Access Compliance Report

Public Rights-of-Way

(Curb Ramps)

Intersection ID: 49295	Main Street: CREEKSIDE_PARK_RD	Cross Street: ROYAL_WINCHESTER_DR	Location: SE
ADA ID: DA502CFDBB88	Ramp Type: Perp	Initial Pass/Fail: Fail	Overall Compliance: No
Severity Score: 8.75			
Codes/Mitigation Info/Possible Solution		Field Measurements/Component Compliance

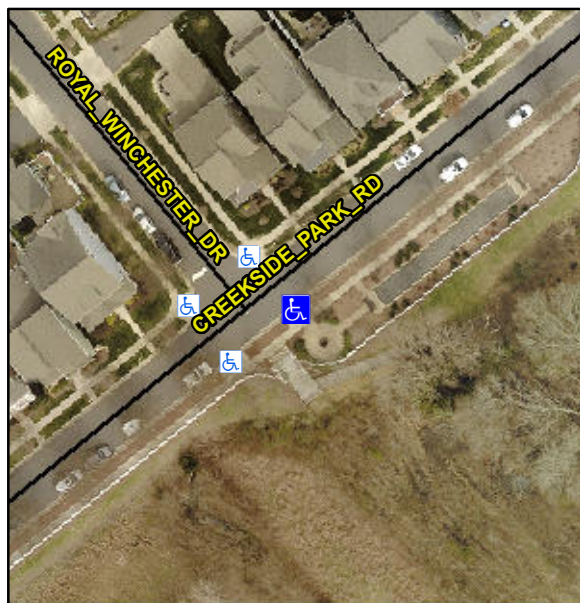
Not Found, R304.5.1

Compliance	Description	Data	Compliance	Description	Data
N/A	Ramp Length (in)	72.0	Yes	Ramp Slope (%)	8.3
No	Ramp Width (in)	47.0	Yes	Ramp XSlope (%)	1.3
N/A	Flare Type LT	N/A	N/A	Flare Type RT	N/A
N/A	Flare Slope LT (%)	N/A	N/A	Flare Slope RT (%)	N/A
N/A	Flare Traversable LT?	N/A	N/A	Flare Traversable RT?	N/A
N/A	Landing Length (in)	N/A	N/A	DWS Provided?	N/A
N/A	Landing Width (in)	N/A	N/A	DWS Contrast?	N/A
N/A	Landing Slope (%)	N/A	N/A	DWS Length (in)	N/A
N/A	Landing X Slope (%)	N/A	N/A	DWS Full Width?	N/A
N/A	Landing Curb? (Y/N)	N/A	N/A	DWS Offset (in)	N/A
N/A	Shared Landing?	N/A			
N/A	Gutter Ponding?	N/A	N/A	Gutter Slope (%)	N/A
N/A	Gutter Lip Ht (in)	N/A	N/A	Gutter X Slope (%)	N/A
N/A	Painted X Walk1?	No	N/A	Painted X Walk2?	N/A
	X Walk 1 Direction	To NW		X Walk 2 Direction	N/A
N/A	X Walk 1 Width (in)	N/A	N/A	X Walk 2 Width (in)	N/A
	X Walk 1 Slope (%)	0.9		X Walk 2 Slope (%)	N/A
	X Walk 1 X Slope (%)	0.7		X Walk 2 X Slope (%)	N/A

Remove & Replace Entire Ramp.
